DEVELOPMENT OF PARCEL 8 AND 8A DESIGN REVIEW RESPONSE

I-195 Redevelopment District

Prepared for: The I-195 Redevelopment Commission

Date of Design Review: November 9, 2022

1.1 LOADING AND SITE PLAN

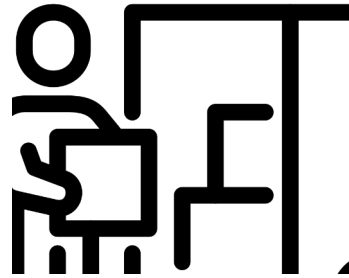
It would be helpful to understand how delivery and receiving is handled

- All trash goes out to the Pike St. loading zone where the dumpsters are located. All retail has trash collection internal to the building.
- The delivery and receiving for S. Main St. is via a secondary access on Tockwotten St. as indicated in the Access Plan.
- We have not finalized the lobby layouts, but there is sufficient area designated to create a package delivery area as well as a small office for onsite PM personnel/leasing.

2.1 ENTRYWAYS

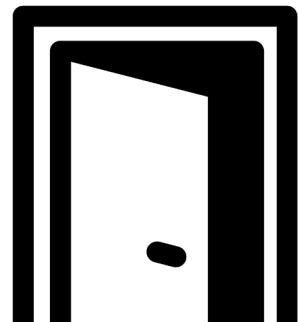
Office lobby would benefit from being more visible from the street.

- The arcade in combination with the pedestal articulates the prominence of the bank.

3.1 FACADE MATERIALS

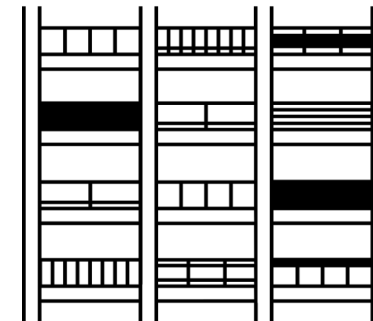
Simplify the material selection by removing the GFRC panels and the shallow aluminum bays.

- The residential buildings are more homogeneous with variations happening within the brick material.
- GFRC and aluminum panels have been removed.
- We have drastically reduced the amount of window wall glazing to improve solar gain as well as acoustics of the wall assembly.

3.2 OFFICE FACADE DESIGN

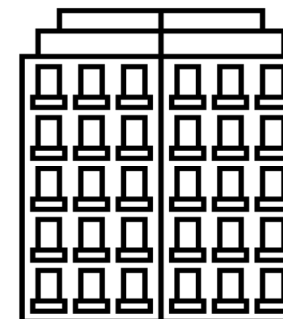
The building feels squat, we suggest a smaller scale cornice profile and a more vertical emphasis to the office grid.

- We have reduced the cornice profile and have revised the office grid

ARCADE & OFFICE FACADE DESIGN

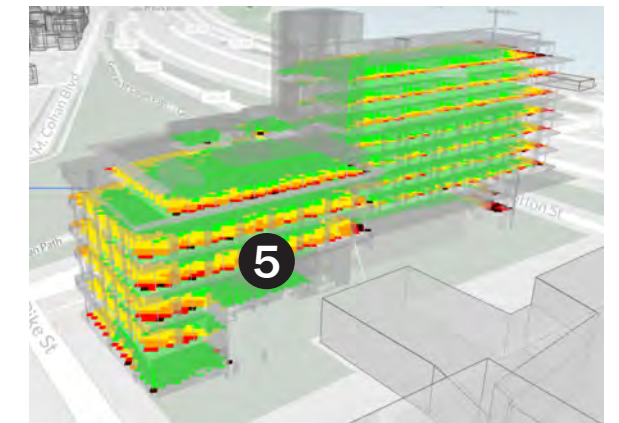
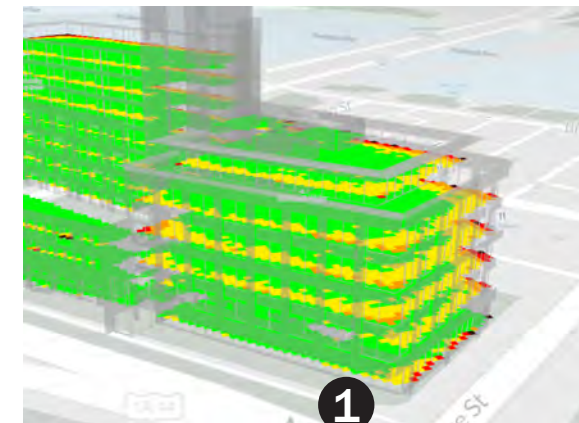
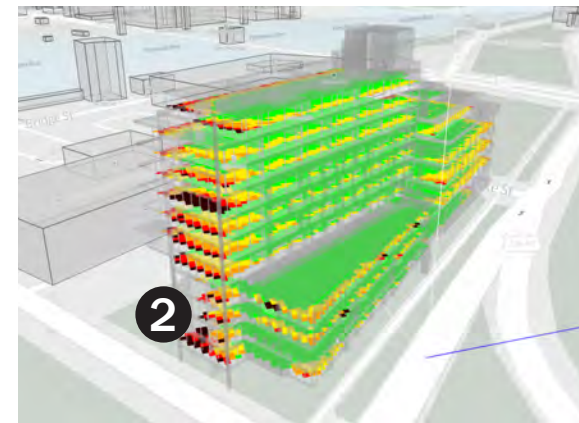
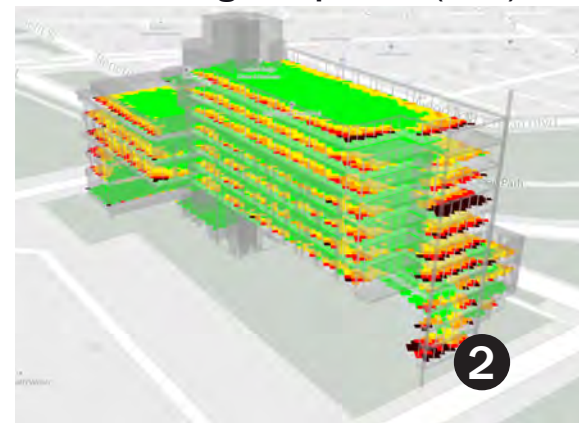
1. *While the arcade adds depth to the building elevation at street level, we are not convinced that a northeast-facing arcade is justified...the arcade terminates awkwardly on its southern end.*

2. *We suggest...a more vertical emphasis to the implied structural grid to make the office building seem less compressed.*

3. *The exaggerated curved cornice of the office building makes the building feel squat. We suggest a smaller scale cornice profile...*

We have maintained the arcade as a multi-functioning element not strictly related to shading conditions. It provides a relief at the street for inclement weather and a formal walking path along the front of the office building that will be well-lit. This provides a space where the massing of the building does not look so heavy; it floats the mass and is complimented by the step-back at the penthouse level.

The Design Team has reduced appearance of large squares on the office building by introducing articulations to the vertical elements. For instance, by introducing curves and profiles that create a dynamism in the curving of the vertical flute the overall form is elongated. The curved vertical flute references water and fluidity, an idea inspired by nature in and around Providence. Additionally, the facade incorporates levels of depth which can be read in the diagram below showing the different orders. The 4th order is another example, which are mullions which divide the windows into long, rectangular sections. This is an effort to break down the form and accentuate its verticality.

The Design Team has minimized the cornice and refined the canopy at the sixth floor to have a better relationship with the overall volume of the building.
